**Office Action Summary**

09/806,031

ARHAB ET AL.

## DETAILED ACTION

Fig. 8

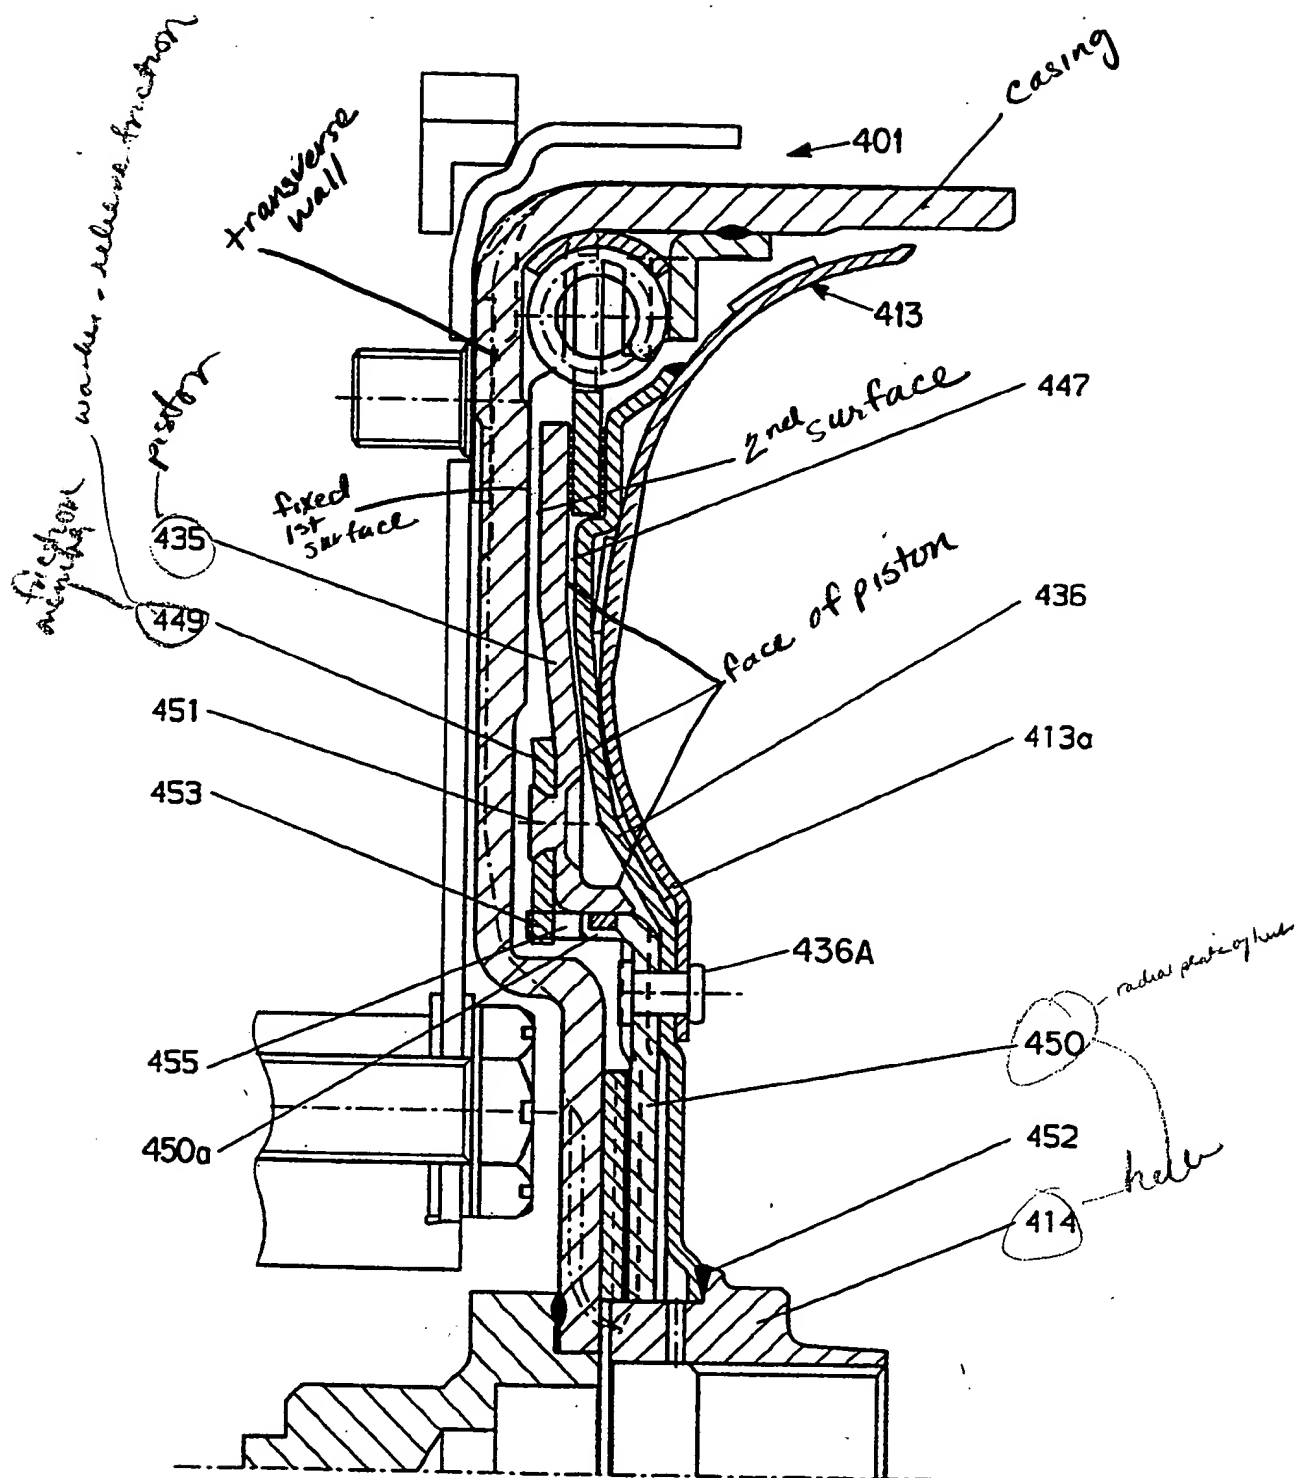
Re: claims 1, 2, 5 and 20. Friedmann et al. show in figure 8 a hydrokinetic coupling apparatus for a motor vehicle comprising a casing as labeled by Examiner in attached copy of figure 8 having a transverse wall as labeled and adapted to be coupled in rotation to a driving shaft, a turbine wheel 413 mounted within the casing and fixed to a hub 414,450 which is adapted to be coupled in rotation to a driven shaft, a fixed first surface as labeled on the transverse wall of the casing, and a lock-up clutch as shown

interposed between the turbine wheel and the transverse wall and comprising a piston 435 carrying a second surface as labeled which lies facing the first surface capable of coupling it releasably to the transverse wall as the piston reciprocates axially, wherein a friction means 449 acts between a face of the piston as labeled opposed to the second surface and an element situated in facing relationship, characterized in that the piston is so configured as to carry the friction means as shown via element 451.

Re: claims 8, 9, 10, and 11. Friedmann et al. show rivet means 451 interposed between the friction means and the piston.

Re: claims 26, 27, and 28. Friedmann et al. show in figure 8 a hydrokinetic coupling apparatus for a motor vehicle comprising a casing as labeled by Examiner in attached copy of figure 8 having a transverse wall as labeled and adapted to be coupled in rotation to a driving shaft, a turbine wheel 413 mounted within the casing and fixed to a hub 414,450 which is adapted to be coupled in rotation to a driven shaft, a fixed first surface as labeled on the transverse wall of the casing, and a lock-up clutch as shown interposed between the turbine wheel and the transverse wall and comprising a piston 435 carrying a second surface as labeled which lies facing the first surface capable of coupling it releasably to the transverse wall as the piston reciprocates axially, wherein the turbine wheel 413 includes an annular ring 413a which may be of divided form as best understood and which is fixed to the hub by means of a rivet 436a, and wherein a friction means 449 acts between the hub and the piston, characterized in that the piston is so configured as to carry the friction means as shown via element 451.

17. Claim 15 is rejected under 35 U.S.C. 102(b) as anticipated by or, in the alternative, under 35 U.S.C. 103(a) as obvious over Friedmann et al. Friedmann et al. shows in figure 8 the friction means located over a projected portion of the piston to the same extent as Applicant. The reference is silent to the way in which the friction means is connected to the projecting portion, nevertheless, the patentability of this product-by-process claim is based on the product itself. Furthermore, since molding is an old and well-known method of producing a connection, burden shifts to Applicant to show an unobvious difference that would result from the claimed processes. See MPEP 2113.

Re: claim 23. Friedmann et al. show the friction means consisting of a ring or an encircling (surrounding) arrangement as shown by virtue of the hole through which the portion 451 passes.
